Turbo HD DVR V3.4.80 Build161028 Release Notes (2016-11-10)

Firmware Basic Information	Firmware Version:	V3.4.80 Build161028
	SDK Version:	V5.2.5.15 build20160906
	Play Library (PlayCtrl.dll)	6.0.0.4
	player	7.3.0.0
	Web version	V4.0.1 build161019
	Client version	V2.5.3.8 build20161012

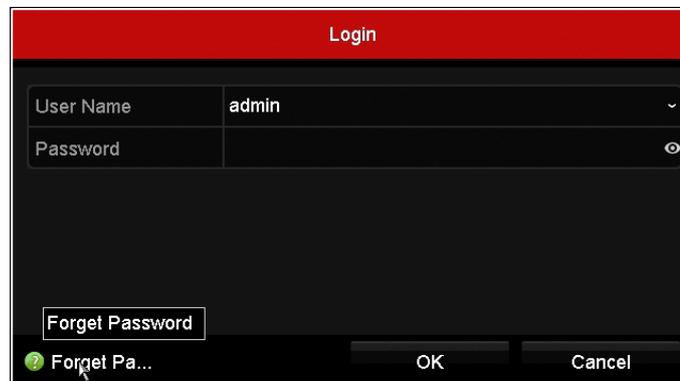
1) **Password recovery on local**：Export the GUID file when activating the device or export the GUID file from the *User Management* interface. When forgetting the password, click the **Forget Password** in the login interface, import the GUID file, and recover the password.

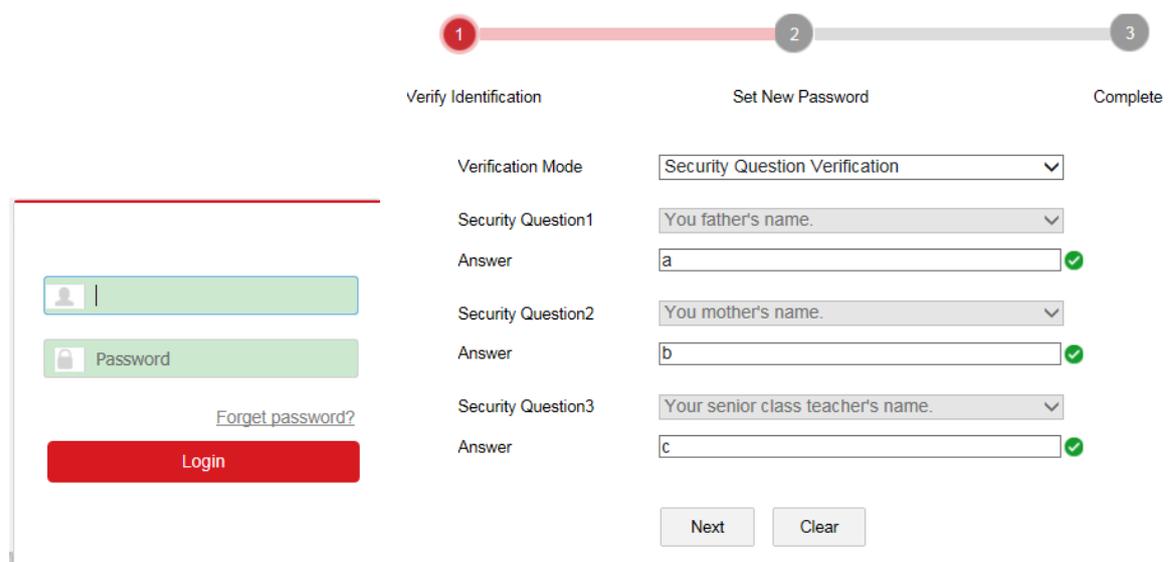
2) **Password recovery remotely in the same local area network**：Recover the password remotely by answering questions set before, or import the GUID file. Recovering or changing the password wouldn't make questions invalid.

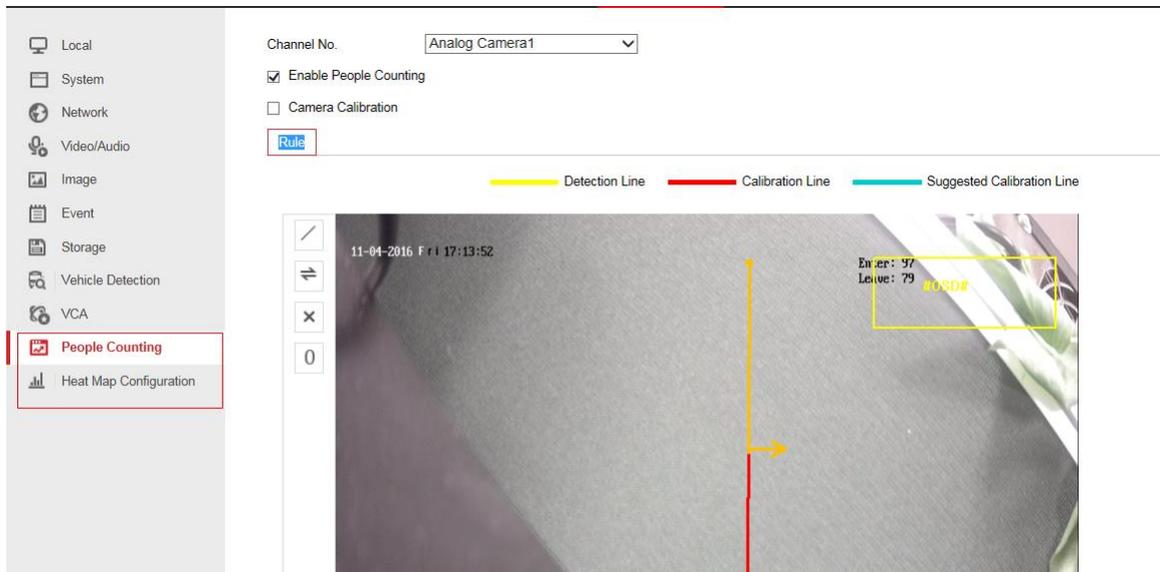
iii. 73&81&90HUHI-Fx/N series newly support one analog channel **People Counting** or **Heat Map** function.

Note: VCA functions (intrusion detection, line crossing detection and sudden scene change), people counting and heat map are mutually exclusive. Only one of these three functions can be supported one time.

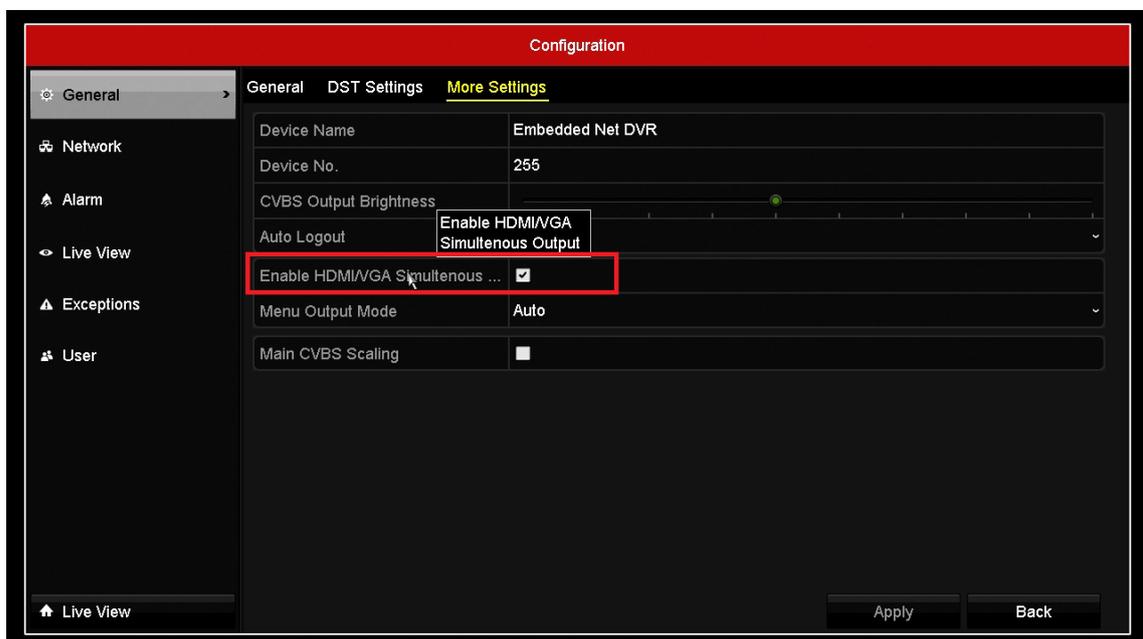
iv. 7608/16HUHI-Fx/N、73/8100HQHI-Fx/N series newly support VGA/HDMI non-simultaneous output configurable function.

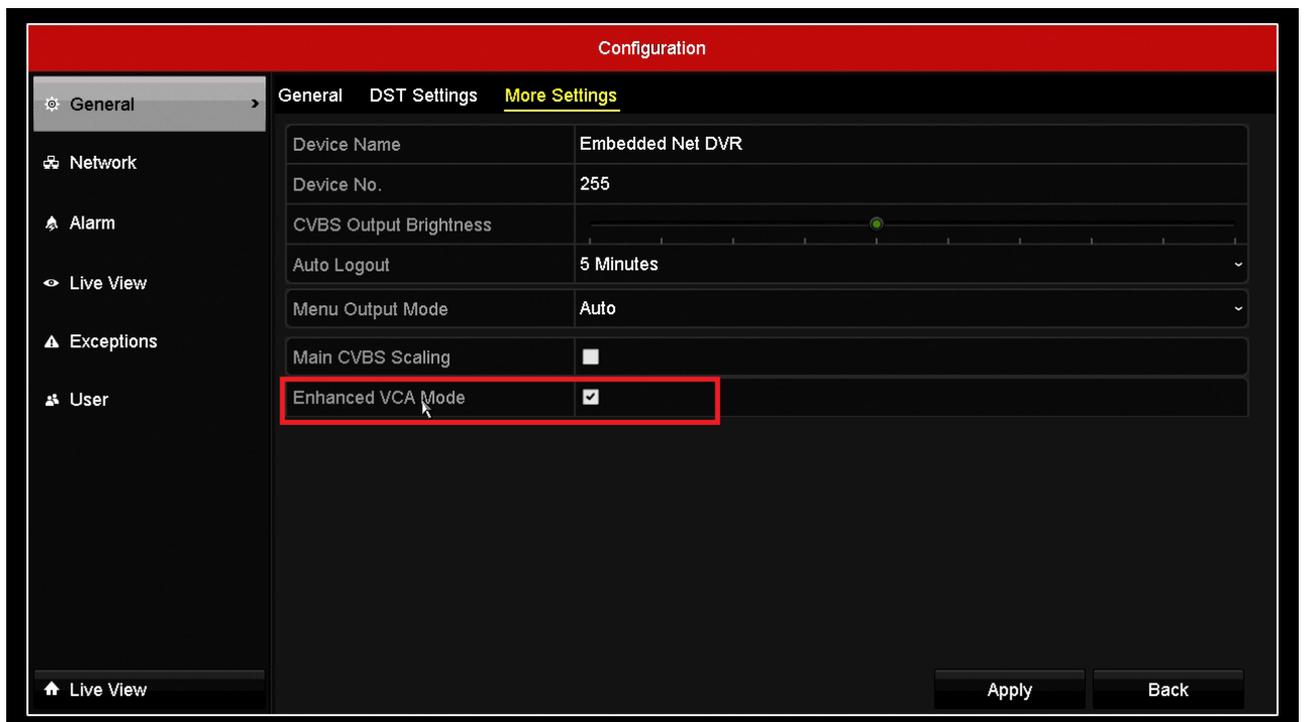
2) 7208/16HUHI-F/N all channel VCA functions and 2K/4K output is mutually exclusive。When **Enhanced VCA Mode** is enabled, these two device can support all channel VCA function, but 2k/4k output is not available；when **Enhanced VCA Mode** is not enabled, 2K/4K output is supported and only 2 channel VCA functions supported.

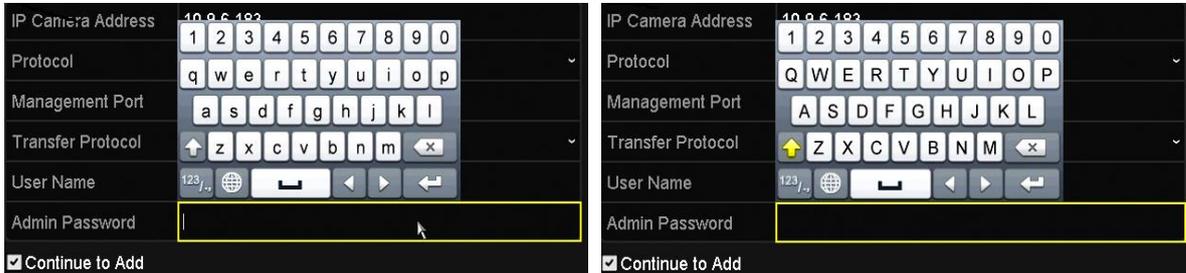
xiii. Optimize the GUI of soft keyboard which distinguish the upper case from lower case. In the previous version, it was all upper case. Just by one left-clicking the [icon], it will switch the letter case.

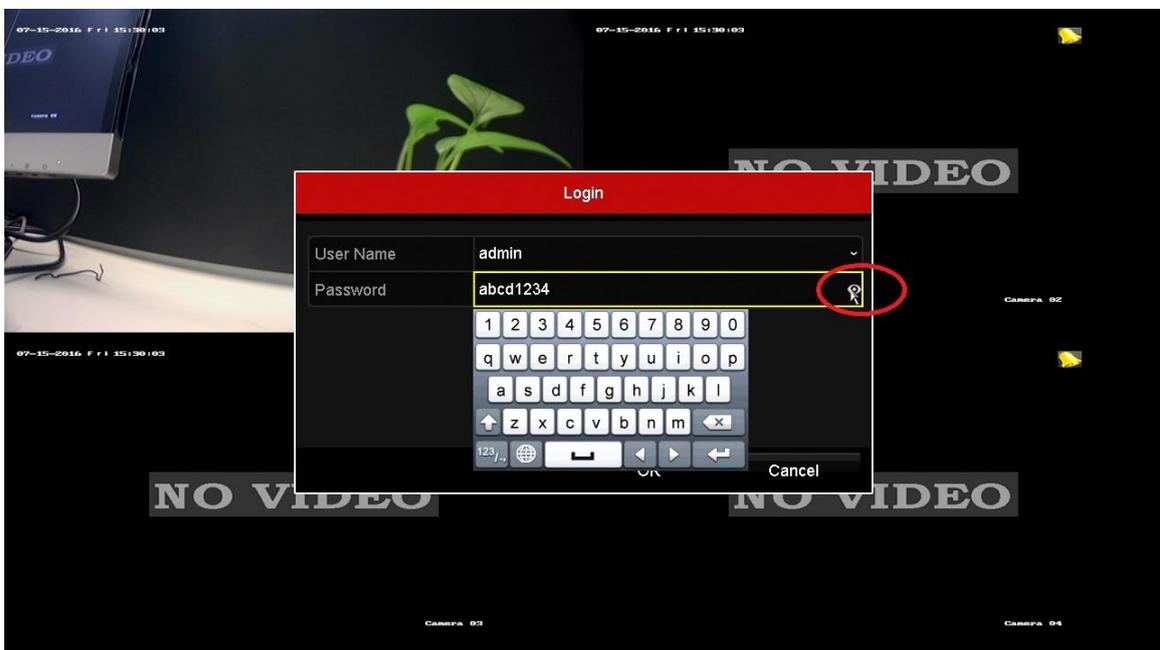
xiv. Modify the display of Clear-text password: lift-click the icon, it will show the clear-text password all the time, lift click the icon again, it will hide the clear-text password.
